1 **IN THE MATTER OF** the *Labrador Interconnected*
2 *System Transmission Expansion Study*

5
6 **Request for information of the Iron Ore Company of Canada (“IOC”)**
7 **to**
8 **Newfoundland and Labrador Hydro (“NLH”)**
9

Docket R-4058-2018, exhibit HQT-3, document 3, Figure 11, p.15 (http://publicsde.regie-energie.qc.ca/projets/471/DocPri/R-4058-2018-B-0010-Demande-Piece-2018_07_27.pdf)

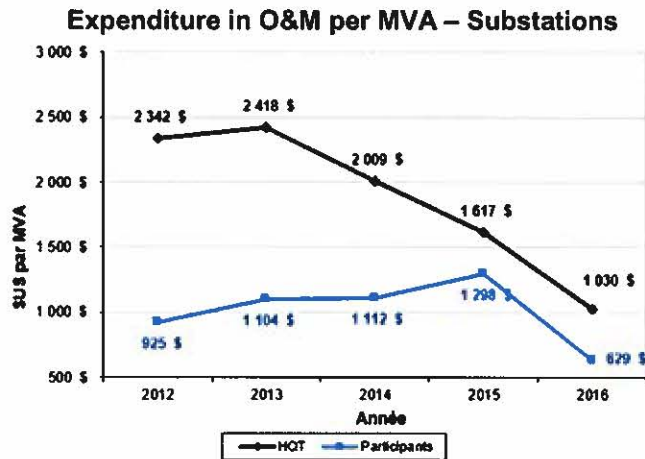
Hydro-Québec TransEnergy (HQT) benchmarks annually similar expenses but reports industry benchmarks from P.A. Consulting and the Canadian Electricity Association (CEA) of a different order of magnitude:

IOC – NLH – 052: Please provide the other O&M benchmarking studies NLH has participated in, acquired or has access to.
